TO: Jennifer Fitch, PE Project Manager Vermont Agency of Transportation	DATE	PROJECT NO.
	9/23/2014	Brookfield BRF FLBR (2)

COPIES	NUMBER	DESCRIPTION	CODE
1		FRP Fabrication NCR 9 - Pontoon 3 Tape Inclusion	H

**Brookfield BRF FLBR (2)**

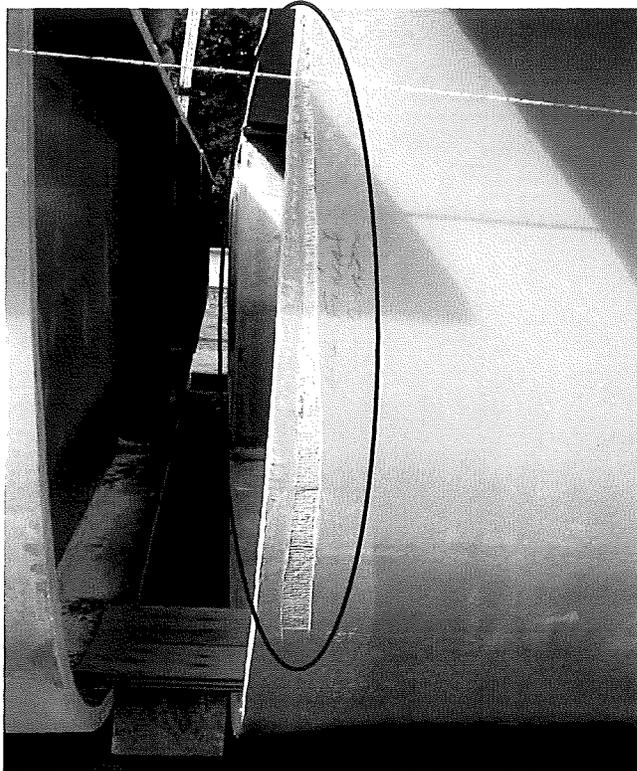
On September 18, Kenway identified an inclusion in the exterior of Pontoon 3 just behind the C-veil layer, which turned out to be a narrow strip of tape. The C-veil and tape were carefully removed from the laminate by cutting around the perimeter of the inclusion.

Kenway plans to clean the area and spread a layer of thickened resin over the structural fiber to restore the exterior surface and bring it flush to the surrounding mold surface.
